## **STAFF DEVELOPMENT COMMITTEE REPORT**

**To:** Plan Commission  
**Prepared By:** Latika Bhide, Development Planner  
**Meeting Date:** May 27, 2015  
**Date Prepared:** May 21, 2015  
**Project Title:** Northwest Crossings  
**Address:** 1501 and 1421 W. Shure Drive.

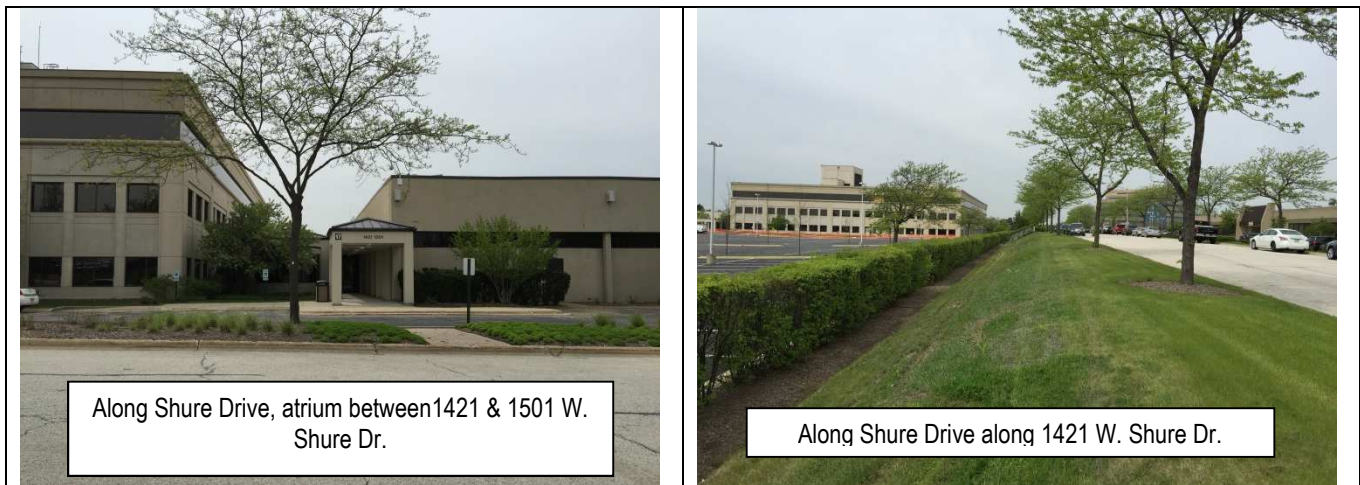
The existing detention basin on the west side of proposed Lot 1 is designed to old MWRD standards. Ordinance No. 14-002, which repealed Ordinance numbers 94-026 and 94-098 (approved as part of the request to demolish 1441 W. Shure Drive) included the condition that any future redevelopment of the property shall require updating the storm water management facilities to current Village standards. As previously stated, the existing parking at the southwest corner of Lot 1 is proposed to be removed and the detention basin enlarged. The petitioner has provided preliminary engineering which is acceptable. As part of the Final Plat approval, final engineering and detention calculations must be submitted to ensure compliance with Village standards and MWRD requirements.
